Subject: Duke Energy Carolinas, LLC
William States Lee III Nuclear Station – Docket Nos. 52-018 and 52-019
AP1000 Combined License Application for the
William States Lee III Nuclear Station Units 1 and 2
Revised Supplemental Response to Request for Additional Information Letter
064, RAI 09.02.01-6
Ltr# WLG2014.03-01

**Lee Nuclear Station Revised Response to Request for Additional
Information (RAI) Letter No. 064, RAI 09.02.01-6**

NRC RAI Number: 09.02.01-006

Revision to FSAR Figure 9.2-201

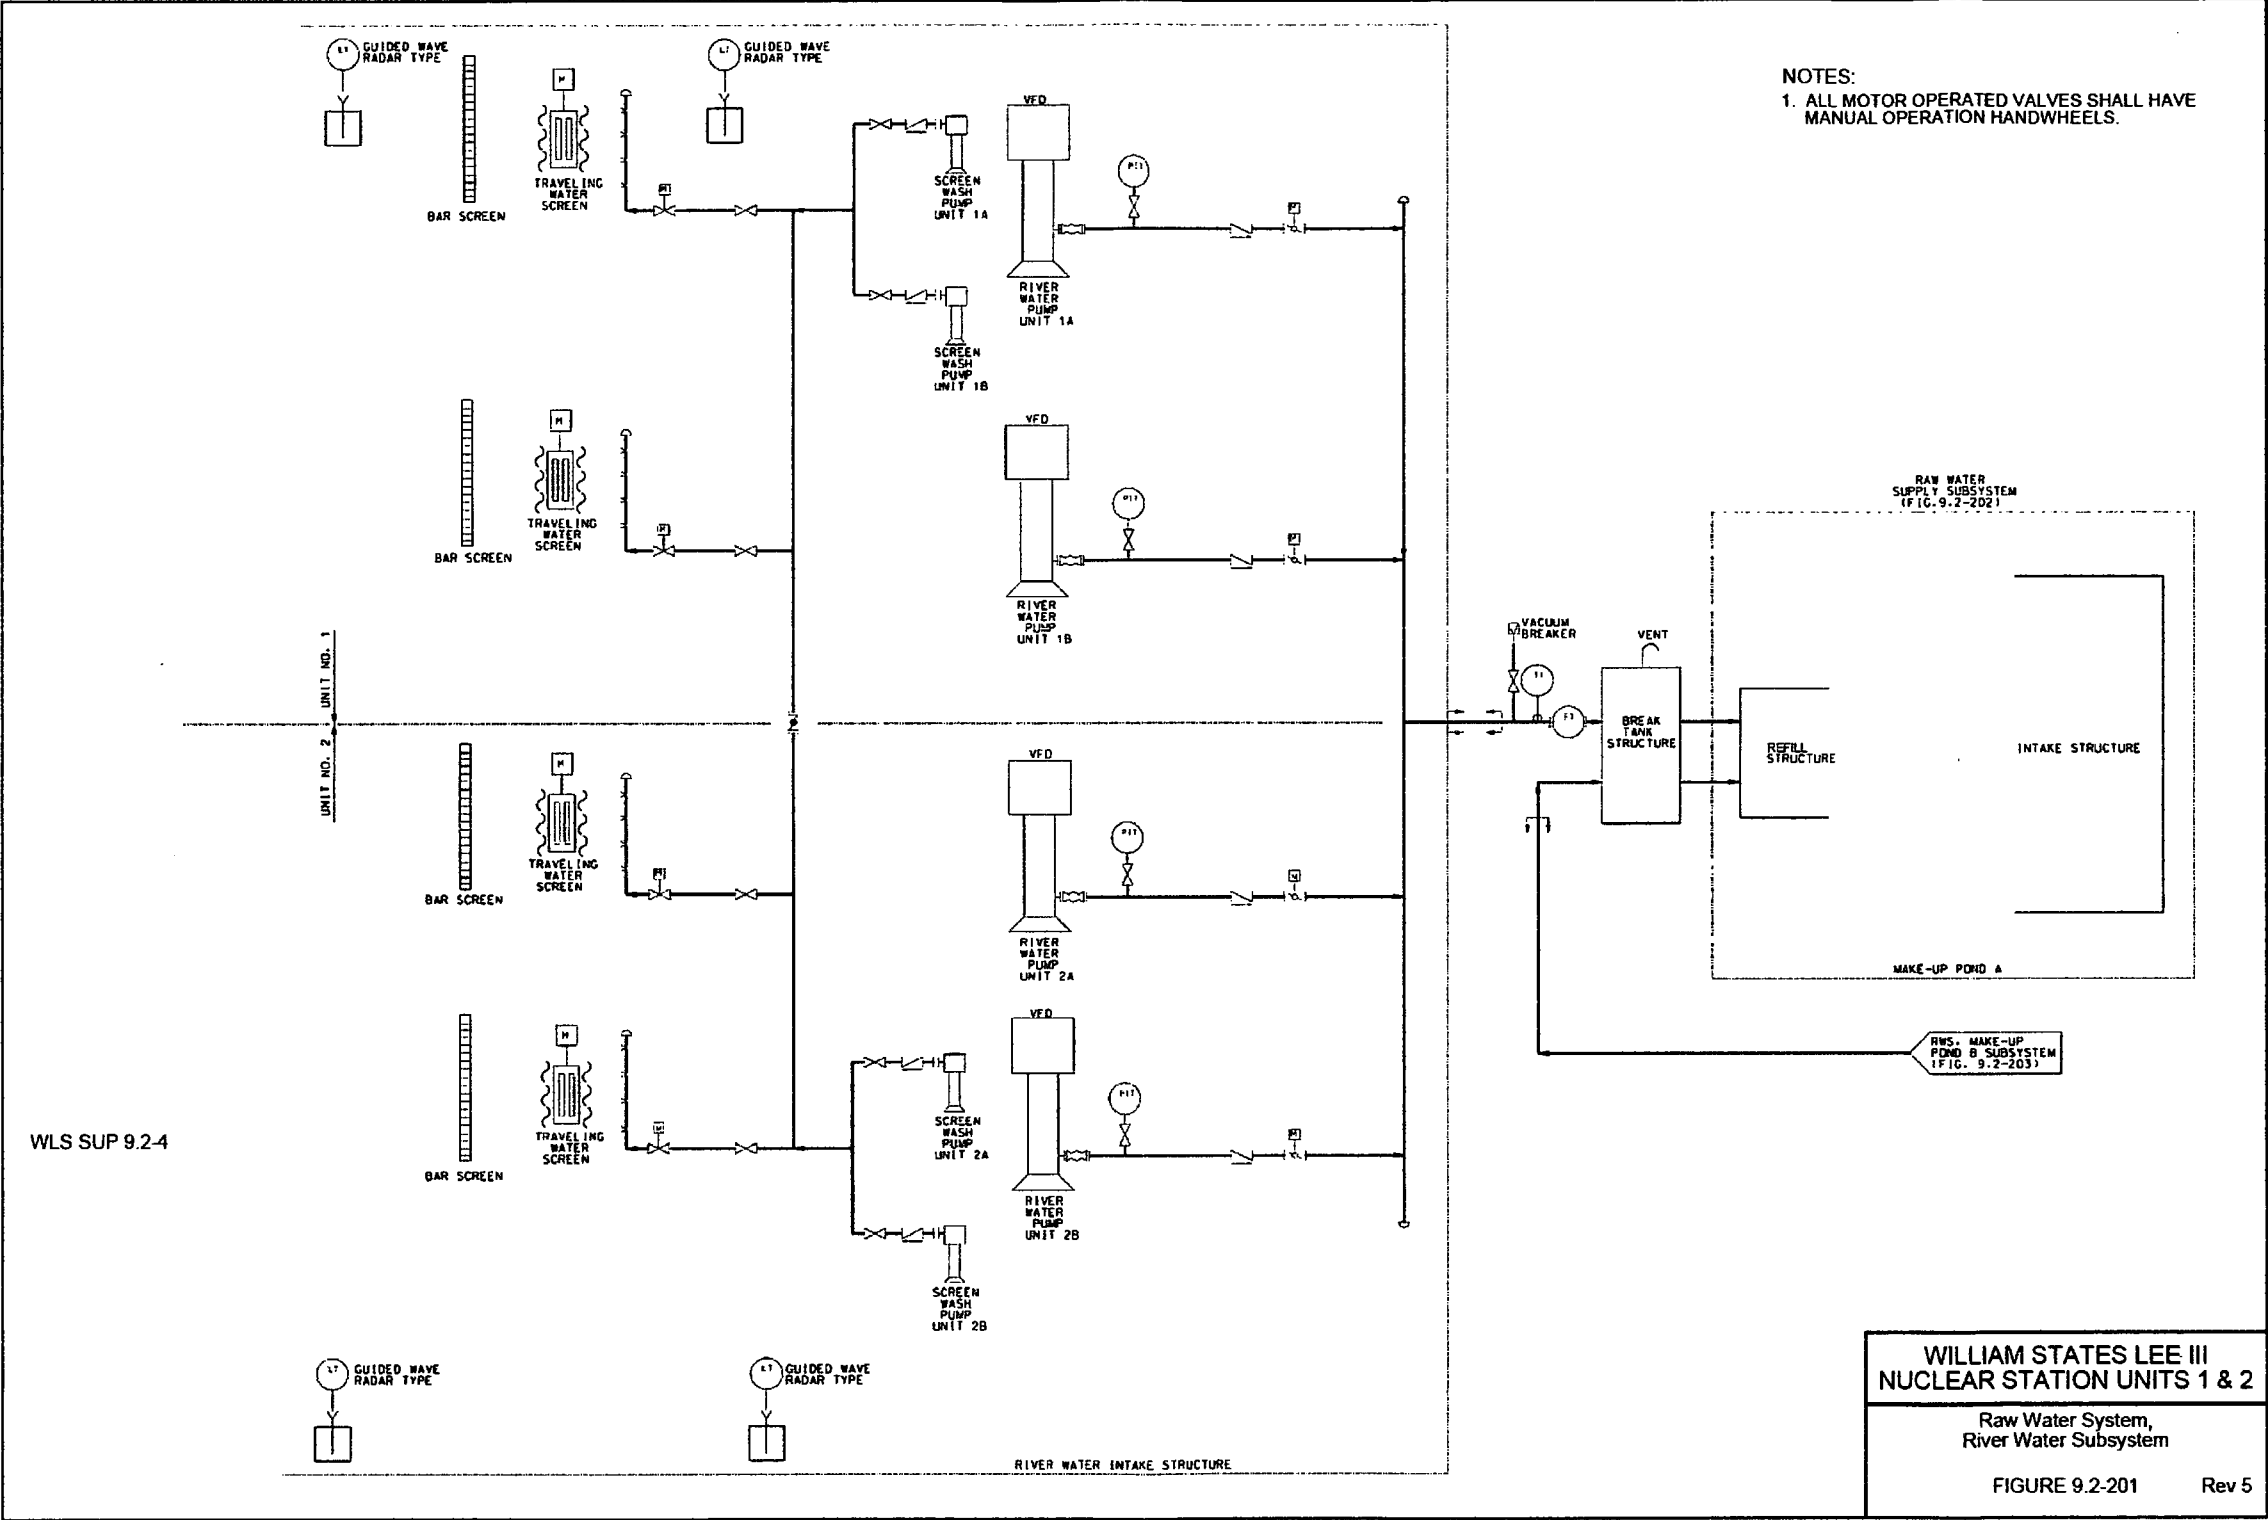
FSAR revisions are necessary to incorporate design changes being made to the number of pumps in the Raw Water Supply Subsystem (Make-Up Pond A intake). The number of pumps is being changed from three pumps per unit (six total) to two pumps per unit (four total). This change to the conceptual design previously submitted is being made to more closely align the sizing of these pumps with the required make-up flow for the Circulating Water System (CWS) under anticipated normal operation at four cycles of concentration. These changes are reflected in Attachments 2 through 8 and will be incorporated in a future revision of the FSAR.
